Additional Public Comment

I am sending you this letter of support for the Vida Valiente Winery project up for a hearing on December 6th.

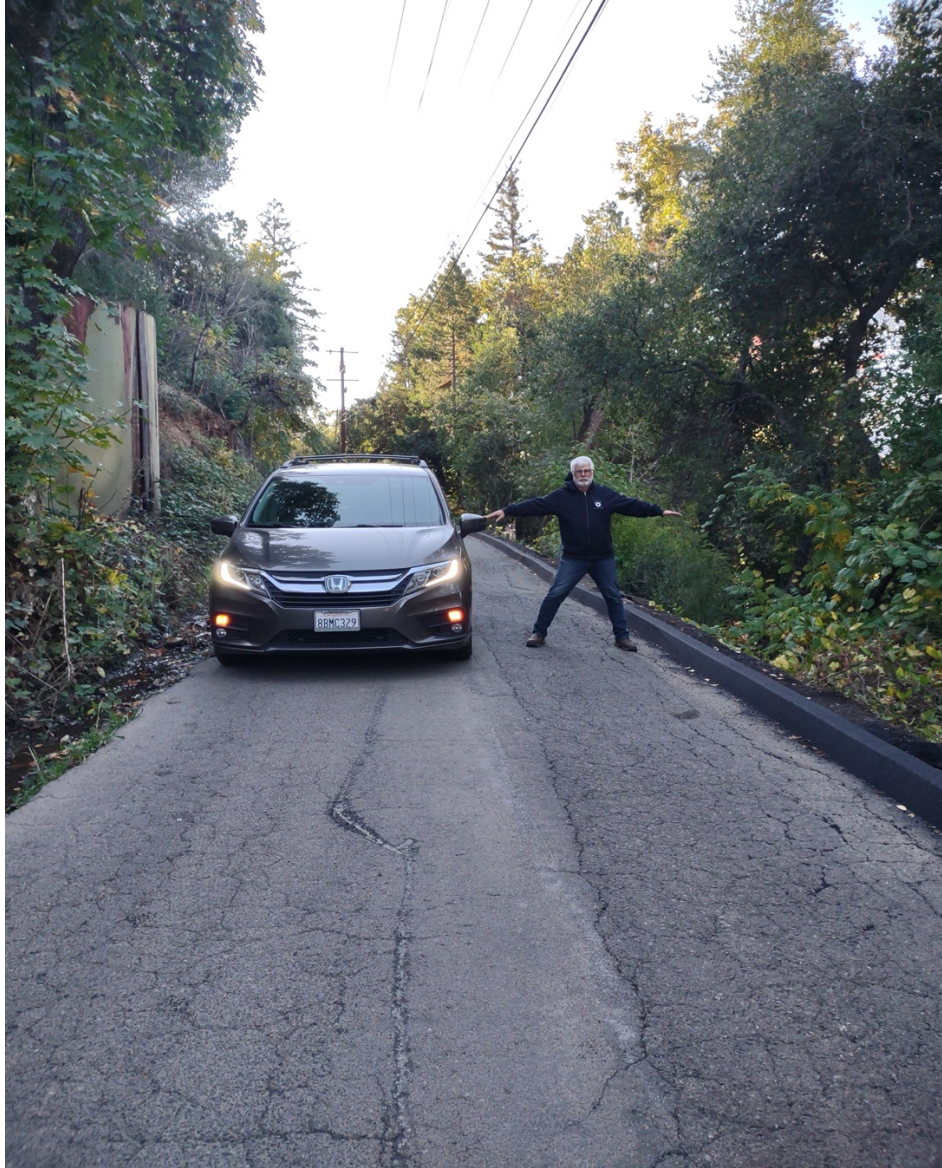
What does the sentence mean where it states that Crystal Springs Road now meets County rural road criteria to have 20-foot pavement with yet it than states this is not true for portions of the road? Either the road meets County rural road criteria, or it doesn't. One should not state that sections are wide and even though there are narrow sections we should look only at the wide sections. It should really be the opposite. The narrow sections of only 12 ft. with drop offs on both sides (one is 12 inches into a culvert and the other side is down an embankment of several feet are far more important than the wide sections). It seems irresponsible to gloss over these narrow impassible sections while implying there are wider sections so ignore the narrow sections. How is this different from stating: There are 2 railroad tracks at many areas so don't worry about the areas of single track. Just let the trains travel as they wish. **As a medical professional I consider the plans as written to be an unnecessary public health hazard.**
